GM CUSTOMER CARE AND AFTERSALES
DCS3212
URGENT - DISTRIBUTE IMMEDIATELY

Subject: 14079C – Safety Recall
Front Axle Right Half Shaft Fracture
Revised Service Procedure

Models: 2013-14 Chevrolet Cruze Equipped with 1.4L Turbo Engine (LUV)

SUBJECT: Front Axle Right Half Shaft Fracture

Service Part Number 13371620 (Manual Trans)

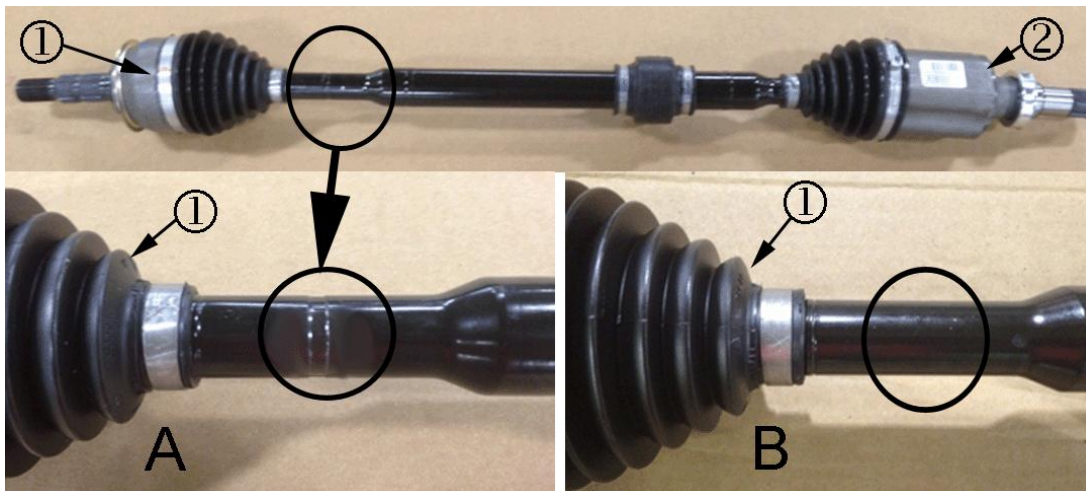
1. Inspect the inboard side of the shaft (shorter portion between rubber isolator and boot) for a green stripe, green dot or combination of green stripe and green dot.
 - If these markings are present, this is a good part.

- If there are no green markings on the inboard portion of the shaft (4) this part should be returned to General Motors under special return message G_0000187857 dated March 18, 2014 (US) or GMP 2014-073 dated March 17, 2014 (CN).

Service Part Number 13334705 (Auto Trans)

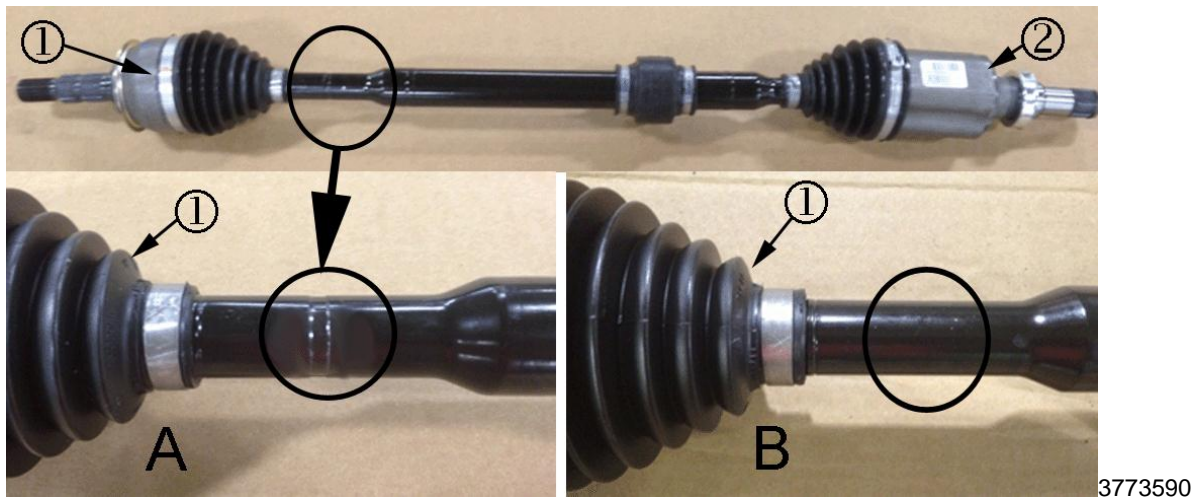
Note: Any additional paint marks found on this shaft can be disregarded.

1. Part can ONLY be used if the outboard side of the half shaft (longer portion of shaft between CV joint and isolator) is a solid painted bar shaft. Same diameter across entire shaft. There are no other identifications on the half shaft to look for.
 - If the part is a solid painted bar shaft, it can be used for service.
 - If part is a tubular non-painted bar shaft, then the half shaft assembly is to be scrapped from inventory.

(1) Wheel Side of Half Shaft (2) Transmission Side of Half Shaft (A) Machined Groove (B) No Groove

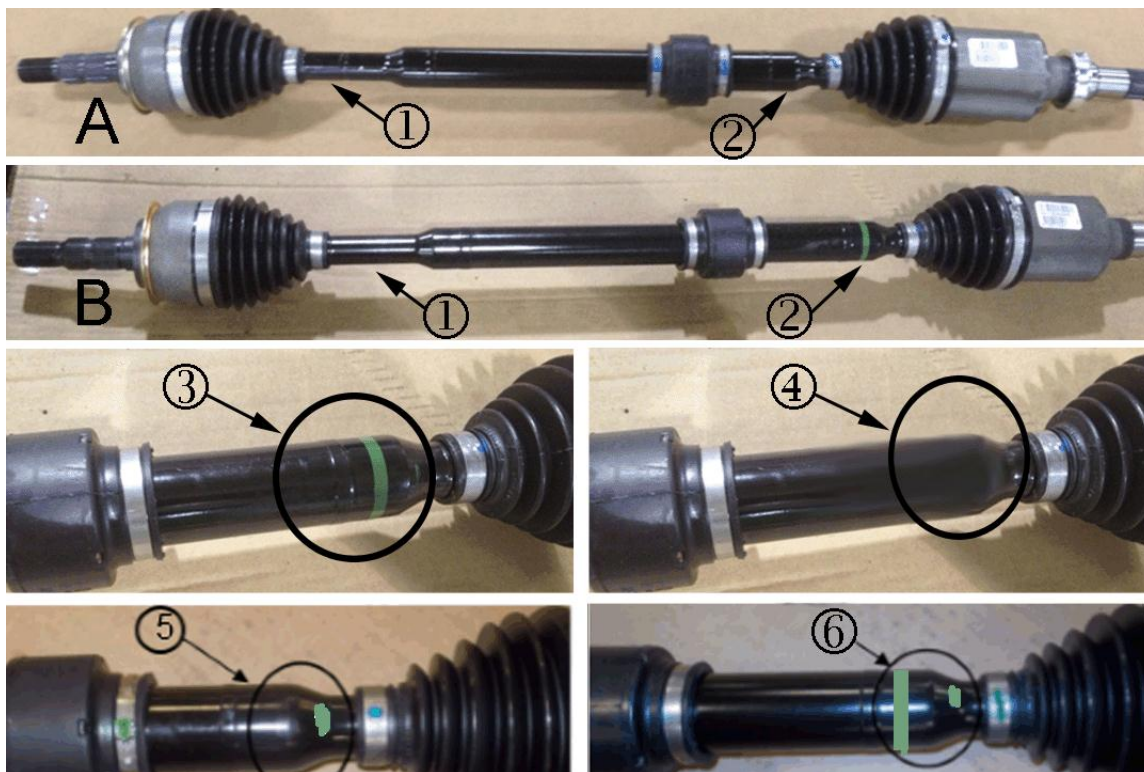
1. Raise and support the vehicle. Refer to *Lifting and Jacking the Vehicle* in SI.
2. Inspect the right (passenger side) half shaft near the front wheel. Determine if a machined groove is present on the half shaft.

- If the machined groove is present (A) on the half shaft, no further action is required. Lower the vehicle.
 - If the machined groove is NOT present (B) on the half shaft, proceed to step 3.
3. Inspect the right (passenger side) half shaft near the transmission. Determine if a green stripe, green dot, or green stripe and green dot is present on the half shaft bar.
